ADDENDUM NO. 1 – October 1, 2012

CITY OF DULUTH

HUTCHINSON ROAD REPAIRS, PROJECT NO. 1135, BID NO. 12-0451-1

MANHOLE PLATE DETAIL

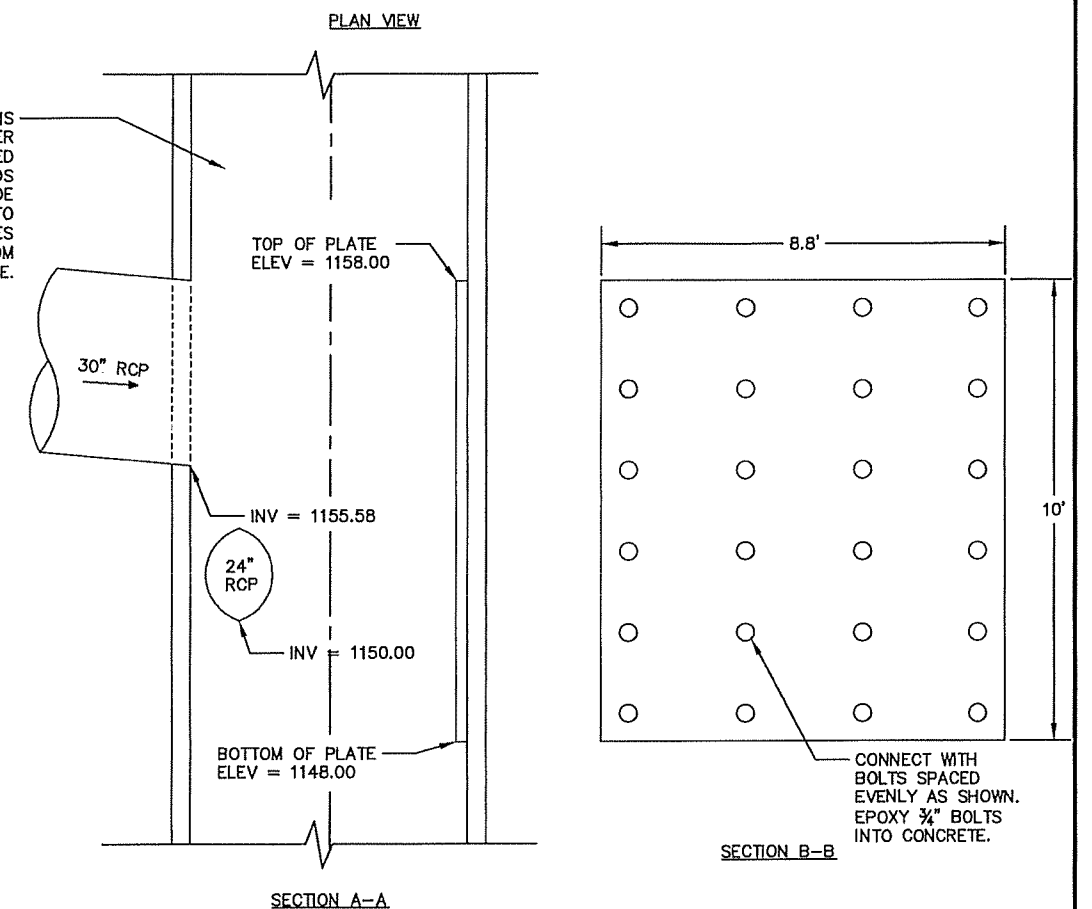
2. Sheet 2 of 5. Delete Standard Plate 3007D.
3. Sheet 4 of 5 - Manhole Plate Detail has been modified and attached.

DRAWN BY: ACO				REVISED STEEL PLATE SIZE, DIMENSION, AND NOTATIONS	I HEREBY CERTIFY THAT THIS PLAN WAS PREPARED BY ME OR UNDER MY DIRECT SUPERVISION AND THAT I AM A DULY LICENSED PROFESSIONAL ENGINEER UNDER THE LAWS OF THE STATE OF MINNESOTA.  Matthew J. Boft, P.E. Date: 09/24/2012 Lic. No. 43913	 PHONE: 218.279.3000 418 W SUPERIOR ST STE 200 DULUTH, MN 55802-1512 www.sehinc.com	CITY OF DULUTH HUTCHINSON ROAD CITY PROJECT NO. 1135	CONSTRUCTION DETAILS	FILE NO. DULUT 121350	4 5
DESIGNER: DRH			REVISED MANHOLE DIAMETER							
CHECKED BY: MJB			ADDED MANHOLE SECTION TIE NOTATION							
DESIGN TEAM	NO.	BY	DATE	REVISIONS

ALL MANHOLE SECTIONS SHALL BE TIED TOGETHER USING FOUR 1" GALVANIZED THREADED RODS. RODS SHALL NOT PORTRUDE MORE THAN 2" INTO STRUCTURE AND HOLES TO BE DRILLED 16" FROM JOINT CENTERLINE.
